Source: Leece-Neville Heavy Duty Systems Division – Arcade, NY

Bulletin No: TSB-1190 **Date:** July 27, 2021

Models: MS4-500

Subject: HM95 Upgrade

MS4-500 Rear View

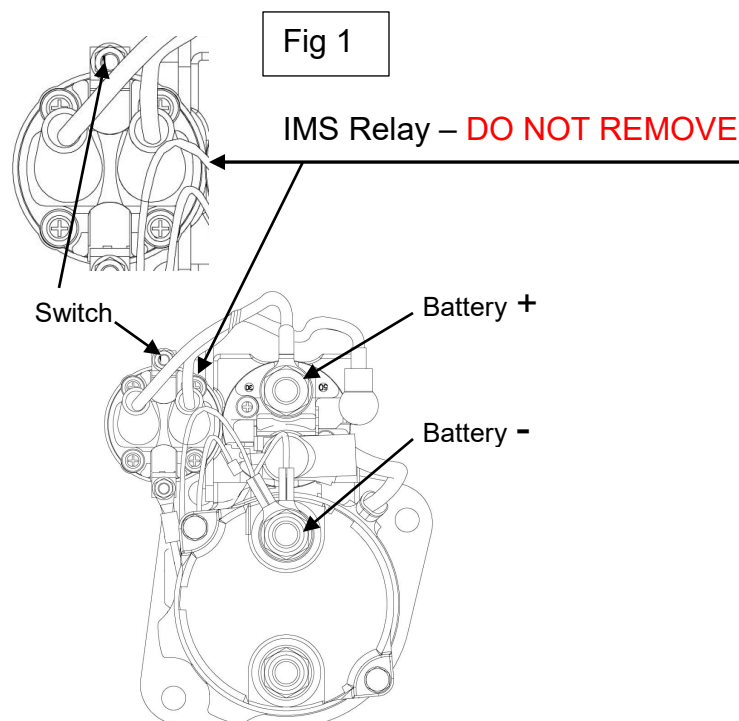
The MS4-500 has been discontinued and in its place is the HM95R3804SEM

The “Switch” connection is now on the IMS Relay (Fig 1)

Torque specs for the connections are as follows:

Battery + : M10 X 1.75, 5-7Nm

Battery - : M10 X 1.75, 5-7Nm

Switch : M5 X 0.8, 1-2Nm
